DEVELOPMENT ASSESSMENT REPORT – DA 076/12 REFURBISHMENT OF EDUCATION FACILITY, LOT 3 DP 1077295 & LOT 1 DP 379892, BRIDGE STREET LITHGOW NSW 2790

1. PROPOSAL

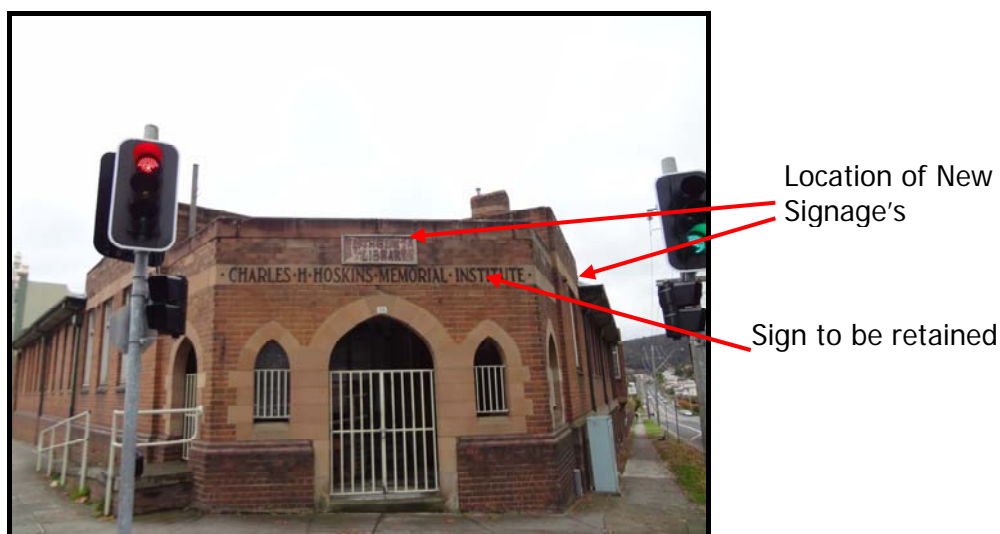
Comment: One “As of Right sign consisting of the UWS logo and letters for 'University of Western Sydney Outreach Campus' is proposed to be installed above the existing Hoskins building signage at the main entry (proposed to be retained).

- A new signature university logo on the eastern façade of the building
- Two smaller identification logos on each side of the main entry and at the Bridge Street entry to the shared pedestrian walkway.
- A smaller identification sign on the northern façade.

It is proposed that there will be one sign located on different building facades which physically separates the signs to avoid visual clutter. The proposed signs will be small and will not dominate the façade when compared to the size of the building. The significance of the existing Hoskins Building will be maintained within the streetscape.

Overall there will be five signs including an As of Right sign; therefore the development complies with Councils Outdoor Advertising Development Control Plan.
